# Access Compliance Report

### (Curb Ramps)

Intersection ID: 31193	Main Street: DICKSON_LN	Cross Street: OLDEN_CT	Location: SW
ADA ID: EDE677905E38	Ramp Type: Perp	Initial Pass/Fail: Fail	Overall Compliance: No
Severity Score: 8.75			
Codes/Mitigation Info/Possible Solution		Field Measurements/Component Compliance

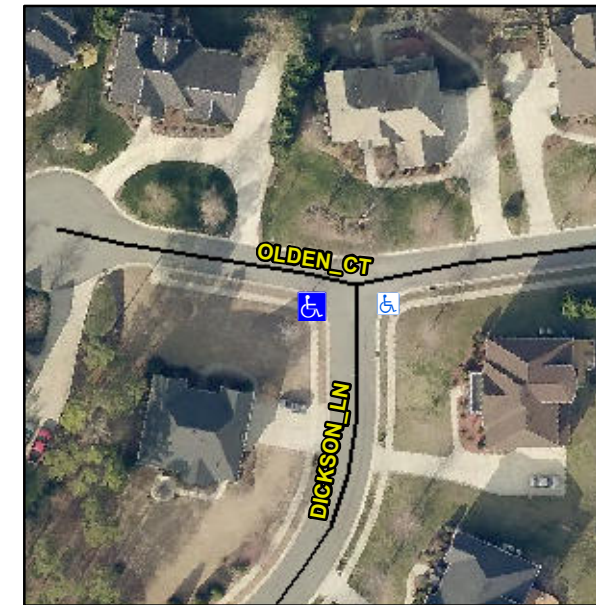
**Remove & Replace Entire Ramp.**

**Not Found, R304.5.1**

Compliance	Description	Data	Compliance	Description	Data
N/A	Ramp Length (in)	48.0	Yes	Ramp Slope (%)	8.1
No	Ramp Width (in)	43.0	Yes	Ramp XSlope (%)	0.5
N/A	Flare Type LT	N/A	N/A	Flare Type RT	N/A
N/A	Flare Slope LT (%)	N/A	N/A	Flare Slope RT (%)	N/A
N/A	Flare Traversable LT?	N/A	N/A	Flare Traversable RT?	N/A
N/A	Landing Length (in)	N/A	N/A	DWS Provided?	N/A
N/A	Landing Width (in)	N/A	N/A	DWS Contrast?	N/A
N/A	Landing Slope (%)	N/A	N/A	DWS Length (in)	N/A
N/A	Landing X Slope (%)	N/A	N/A	DWS Full Width?	N/A
N/A	Landing Curb? (Y/N)	N/A	N/A	DWS Offset (in)	N/A
N/A	Shared Landing?	N/A			
N/A	Gutter Ponding?	N/A	N/A	Gutter Slope (%)	N/A
N/A	Gutter Lip Ht (in)	N/A	N/A	Gutter X Slope (%)	N/A
N/A	Painted X Walk1?	No	N/A	Painted X Walk2?	N/A
	X Walk 1 Direction	To E		X Walk 2 Direction	N/A
N/A	X Walk 1 Width (in)	N/A	N/A	X Walk 2 Width (in)	N/A
	X Walk 1 Slope (%)	0.4		X Walk 2 Slope (%)	N/A
	X Walk 1 X Slope (%)	2.7		X Walk 2 X Slope (%)	N/A
